66106A-08A

SERVICE NOTE

66106A DC Power Supply

The instrument will not communicate or will not complete self test. Parts Required:

Figure 2

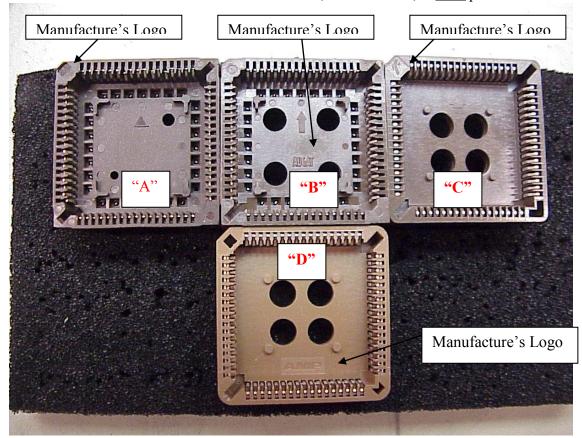
This figure should be used to identify **GOOD** sockets and a potential defective socket. The **16-Bit MCU 16 MHZ 68PLCC CMOS IC** (P/N 1821-1479) is <u>NOT</u> pictured.

The following information will help identify each socket type and manufacturer. The manufactures logo can be identified as shown. After the **16-Bit MCU 16 MHZ 68PLCC CMOS IC** has been removed There are also mold markings that can be easily viewed these markings should be used to identify a **Good or Defective socket**.

Socket "A" is a sample of a GOOD AMP socket.

Socket "B" is a sample of a GOOD Tyco/Augit socket.

Socket "C" is a sample of a GOOD FCI socket.

Socket "D" is a sample of a DEFECTIVE Tyco socket.

The sockets above labeled "A","B" or "C are good and should NOT be replaced.

The socket above labeled "D" is considered defective should replaced.

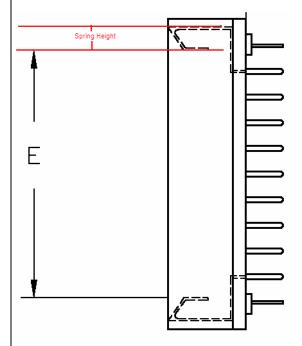
The information described in the following documents is the Corrective Action Plan from Tyco related to the 68 pin PLCC socket MFPN **1-822473-6**.
